SIB 52 10 25

THIRD SEAT ROW ELECTRIC BACKREST ACTUATOR DESIGN  
CHANGE

2025-08-28

This Service Information Bulletin (Revision 1) replaces SI B52 10 25 **dated August 2025**.

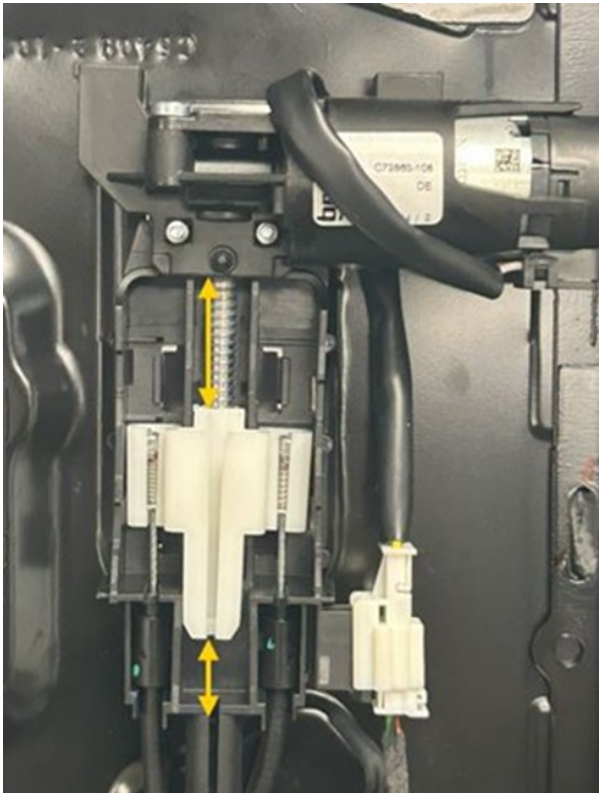
The electric actuator for the third row (3SR) seat changed design and part number, and is used in production vehicles as of March 28, 2025.

- There are two such actuators at this seat row, one for the left seating position; and one for the right

The new actuator’s spindle driver “turns in the opposite direction from the previous design,” thereby requiring a change/update of vehicle’s software.

The improved part fits vehicles of all production dates. The new actuator's spindle driver turns in the opposite direction from the previous design, requiring a change in vehicle software.
